**BEFORE THE HEARING EXAMINER
FOR CITY OF KENNEWICK**

In the Matter of the Application of)		
Knutzen Engineering)		No. FILE NO: PP 21-02 / PLN-2021-01979
)		
for Preliminary Plat Approval)		FINDINGS, CONCLUSIONS,
(Crimson Hills))		and DECISION

To: Matt Halitsky, Planner
From: Joe Seet, Assistant Traffic Engineer
Date: October 28, 2021
Re: Traffic Engineering Summary of Comments for 9757 W Clearwater Ave.
Crimson Hills - Duplex Subdivision PP 21-02_PLN-2021-01979
Project: PP 21-02/PLN-2021-01979

Proposed Internal Streets

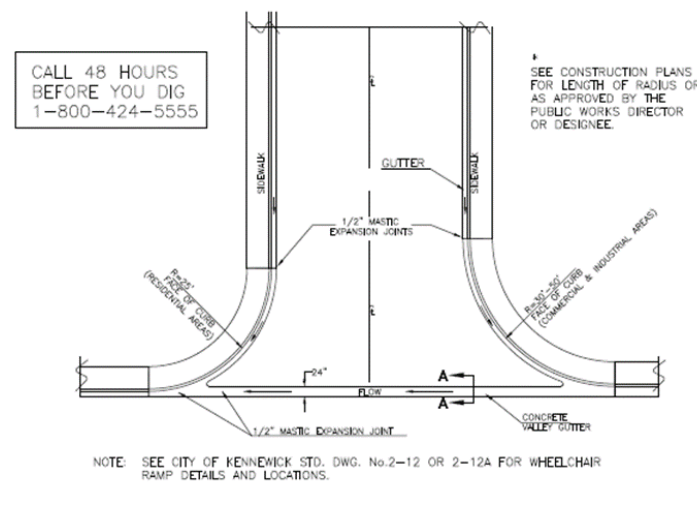
1. All proposed internal streets are functionally classified Local Street and full width roadway improvements, including pavement, curb, gutter, sidewalk and street lighting, are required per City of Kennewick Standard Drawing 2-1.
2. Record 18' public sidewalk, utility and irrigation easement along the proposed development's frontages for all of the subdivision internal streets.
3. The proposed internal local street centerline radius are to meet KMC 5.56.275(1) requirements.

4. The proposed internal local street intersections with W, 10th Ave. radius are to meet KMC Standard Drawing No. 2-9 for intersection design guidelines.

5. Corner parcels (Lots 1, 53, 54 and 38) at public roadway intersections with W 10th Ave will need to meet minimum Corner Clearance requirements per KAC 13-46-110.

Figure 10
Minimum Corner Clearance

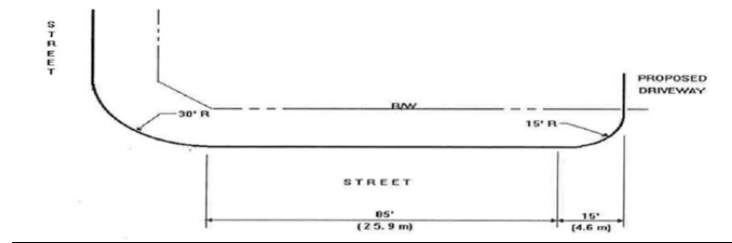
13-46-110: Corner Clearance: All direct access driveways shall be constructed such that the point of tangency of the curb radius return closest to a signalized or stop-sign controlled intersection be at least 100 feet (30.5 m) from the corner right-of-way of the intersecting street (see figure 10). Access driveway(s), if approved by the Traffic Engineer, that are within 350 feet (107 m) of an existing or planned signalized intersection, or the intersection of arterial and/or collector streets, or major traffic generating access (over 1,000 vehicle per day) may require restricted vehicle movements as documented in a traffic impact study and as determined by the Traffic Engineer.
